PURPOSE AND ACTIONS FROM THE NEPA DOCUMENT

The scoping document states that: 1) “The primary purpose of this project is to recover Gold Creek bull trout, ...”, 2) Annual dewatering of Gold Creek is a significant cause of bull trout mortality, and 3) proposed actions, focused on the “primary contributors to seasonal dewatering”, include reconstruction of Gold Creek Pond, Heli’s Pond, the channel of Gold Creek and a groundwater drainage system under Starwater cabins.

SUMMARY OF COMMENTS

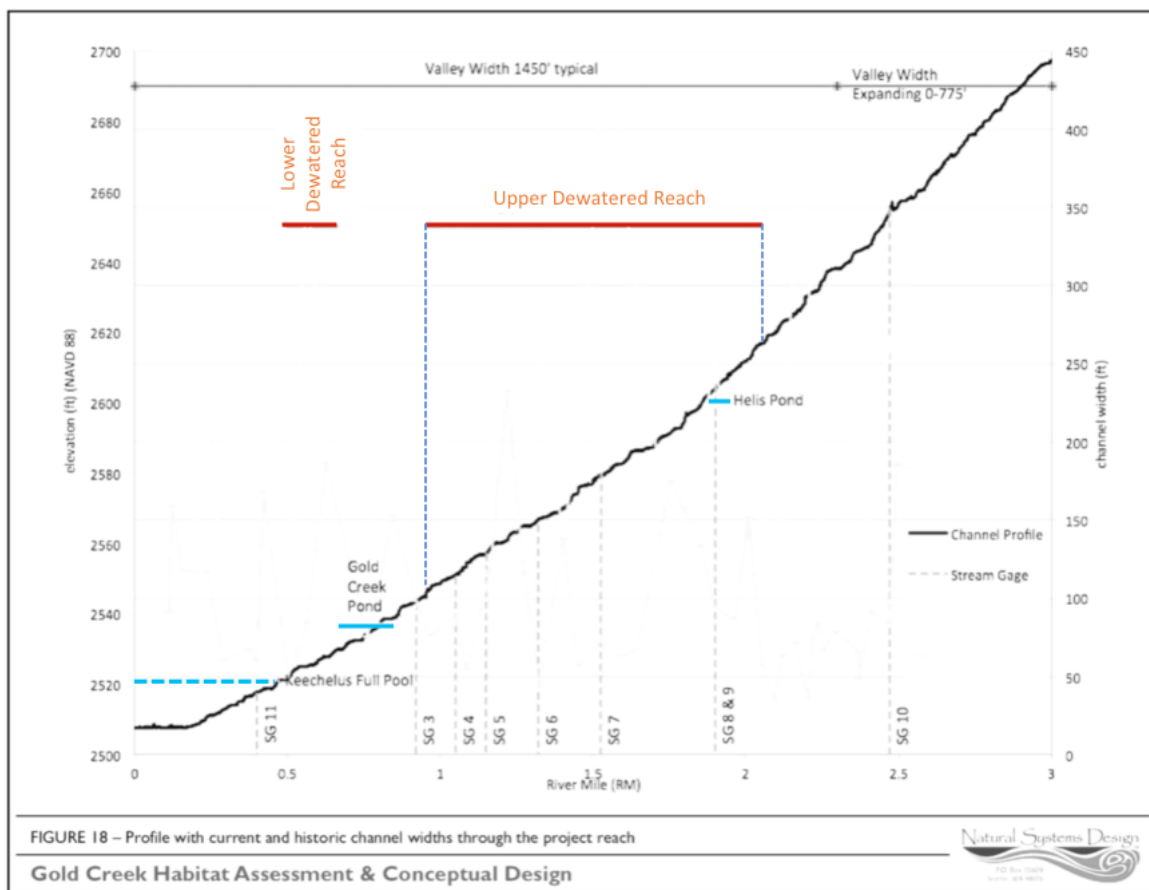
This figure adapted from of NSD's 2013 draft Hydrology Figure 18 addresses feasibility. It shows that the length of the dewatered reach extends 1.25 miles upstream from the pond and 70 feet above the surface elevation of the pond. In addition, and as noted below, Gold Creek has incurred an a loss of 60% of its April snowpack over the last 70 years, a decline that continues at a rate of approximately 10% per decade. Restoring this reservoir of snow water and adding additional water to offset the ongoing deficit is a necessary specification to fill the creek. Reducing the rate of current losses may slow progression but will not repair the cumulating effect of declining snowpack.

QUESTION: Why doesn't the NEPA proposal include a discussion of the above requirements, the means to achieve perennial flow, and data to estimate the likelihood of achieving this intermediate goal?

USFS sign at Gold Creek Pond

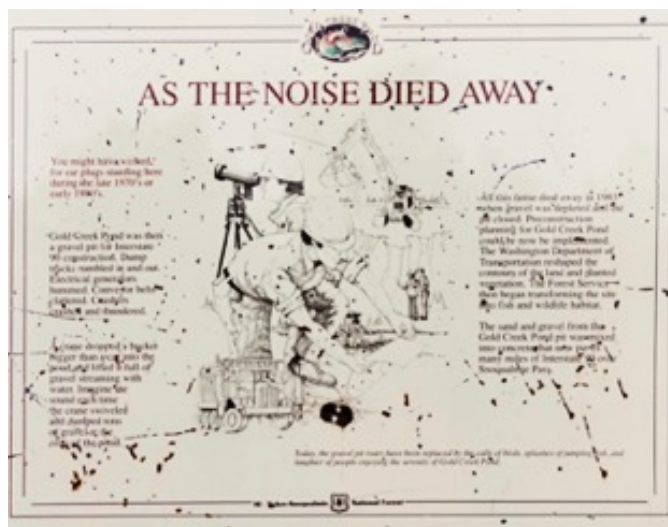
According to the US Forest Service, the Pond was constructed between the late 1970s and 1983.

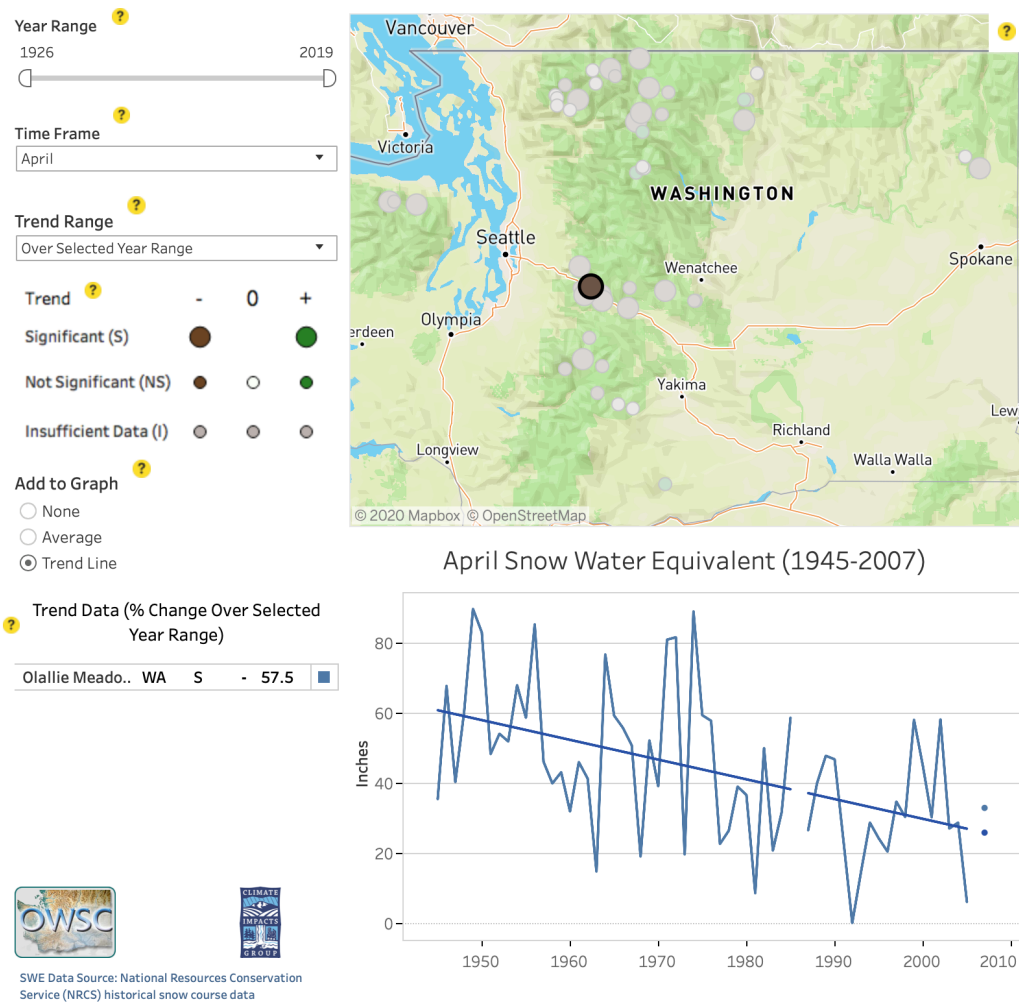
This graph from the Office of the Washington State Climatologist illustrates three points relevant to proposals to restore Gold Creek Pond. The trend line is generated by a large quantity of data and meets standards for statistical significance.

- i. Documentation of seasonal dewatering of Gold Creek in 1968 was preceded by years of rapid loss of April snowpack,
- ii. The creek has lost 58% of its April snowpack with continuing losses of an additional 10% per decade, and
- iii. At the present rate of decline, the quantity of April snowpack remaining in Gold Creek Valley in 50 years will likely be much less than at present.

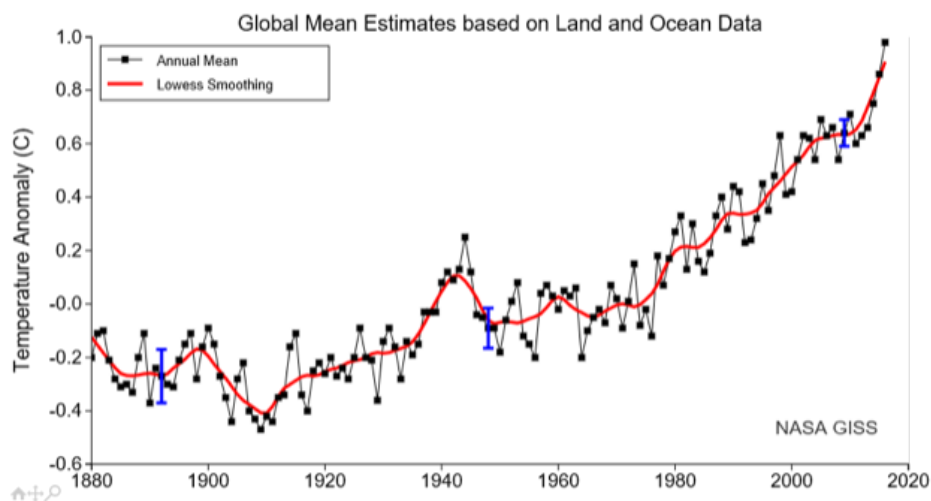
This graph from NASA shows the nearly 70-year trend of increasing global temperature is accelerating. According to NASA, there is nothing to suggest that this trend will moderate.
